Northville DDA Economic Development Committee

Downtown Development Authorities (DDA) Economic Development Committee (EDC) Comments in response to "The Downs" PUD Eligibility Application October 2nd 2018

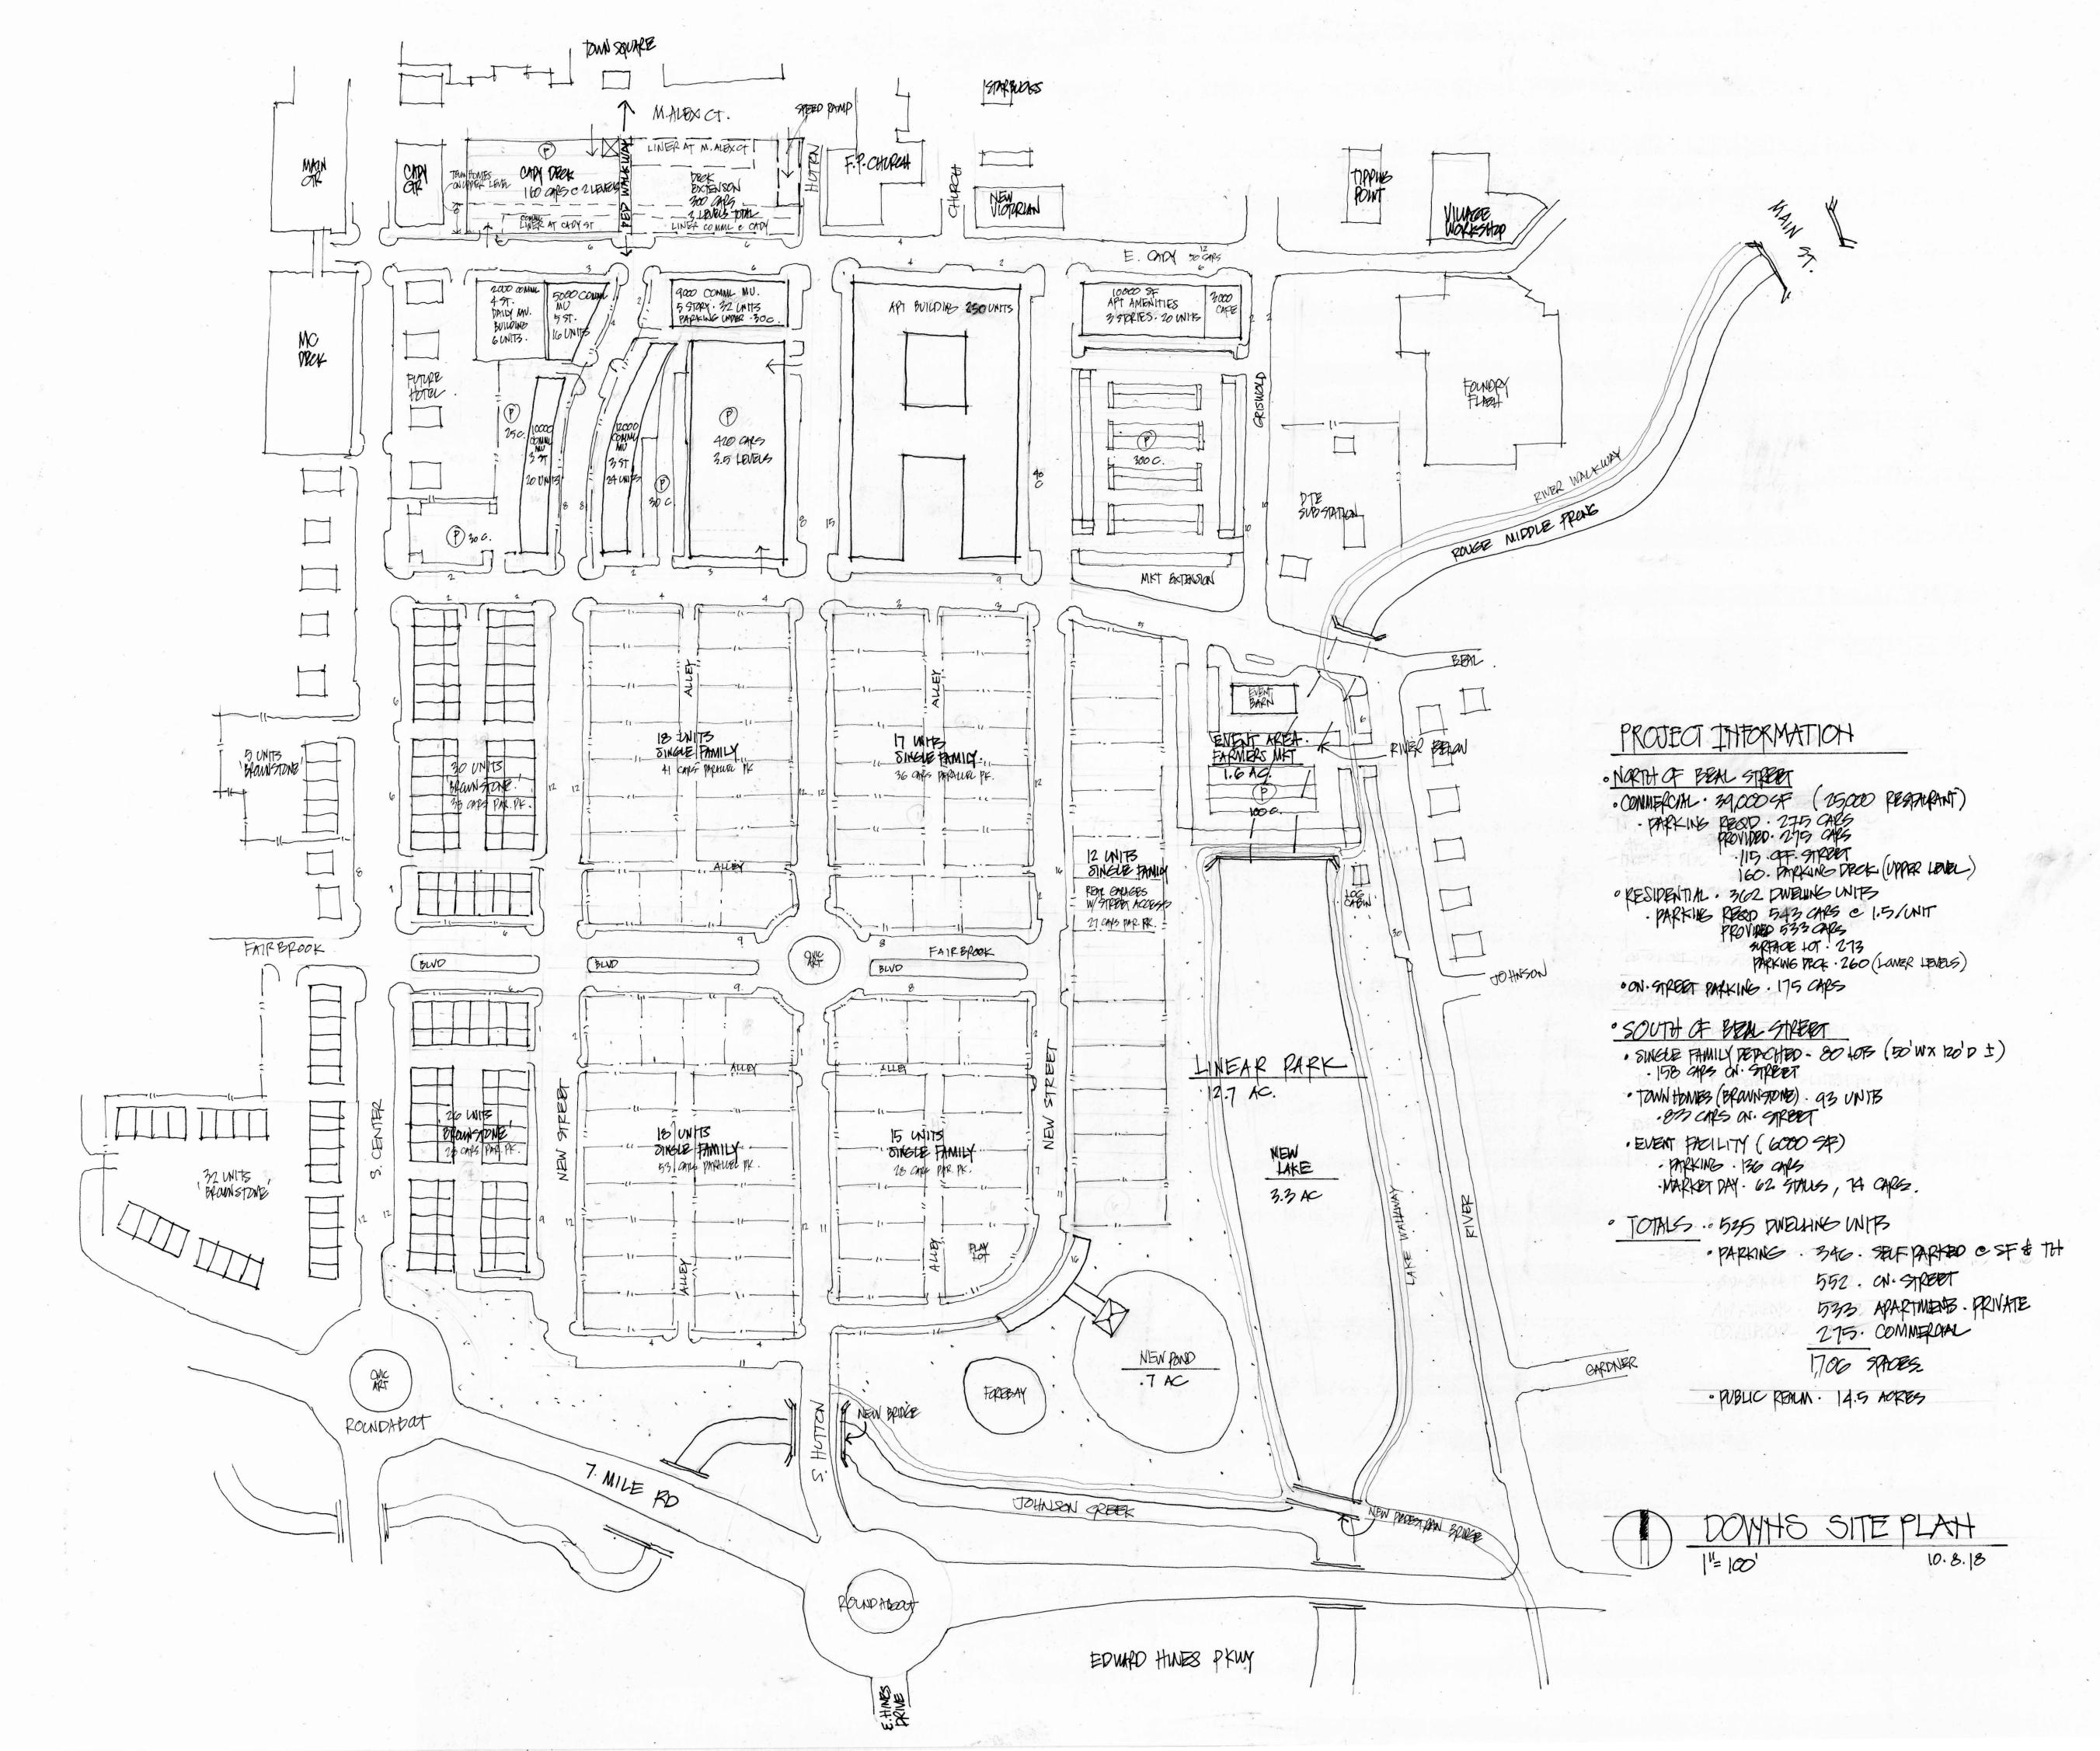
- -535 dwelling units (7% decrease)
- -Lose the single family residential on River Street in order to open up the river as a linear lake (about 3 football fields), with public access along River and walking path around (note the pedestrian bridge).

- -No Pulte town homes. In their place are more single family homes, narrower lot size than currently proposed, alley access (except at the east row with rear garages and street access), individually designed. Could be sold to local builders or to homeowners. Note that the smaller lot size means smaller houses, which is good.

- -Town home product along S Center, "brownstones" with stone and brick cladding, more upscale than proposed by Pulte. Robertson Bros would be a good builder here.

- -Grid blocks with (3) streets N-S connecting to Cady Street (12 total). Note the bridge connection over Johnson Creek to the terminus of EH Parkway at a roundabout. Note the Fairbrook boulevard and roundabout in the center.

- -Roundabout at 7 Mile and S. Center, as proposed by OHM.
- -New commercial on a new N-S street due south of the Town Square. Both sides of the street with micro loft units over. Think "Restaurant Row" with criss-cross festoon lights over. Close down the street for events like we do now. Also move Watermark amenities to a new building along Cady at Griswold intersection. This frees up more commercial along the south side of Cady west off Hutton. Total commercial (net of Watermark amenities) about 39,000 SF.

- -Farmer's Market in a new event facility at ht north end of the linear park with relocated barn for services. Note that the river runs under as it does now.

- -Lots more parking in various venues (larger deck with N-S access, public and private use), more on-srtreet parking, more parking at west side of site, parking in front of residential lots)

- -Possible expanded 3-level Cady Deck with commercial liner potential along Mary Alexander Court and East Cady. Could also have town homes at the top level facing south along Cady. The 2 restaurants along M Alex Ct could relocate to Restaurant Row.

- -Need to dial up the Downs/fairground reference in civic art and other ways.

I think this looks more like a Northville neighborhood, with tree-lined, parked-and-sidewalked streets and predominantly smaller unique houses.
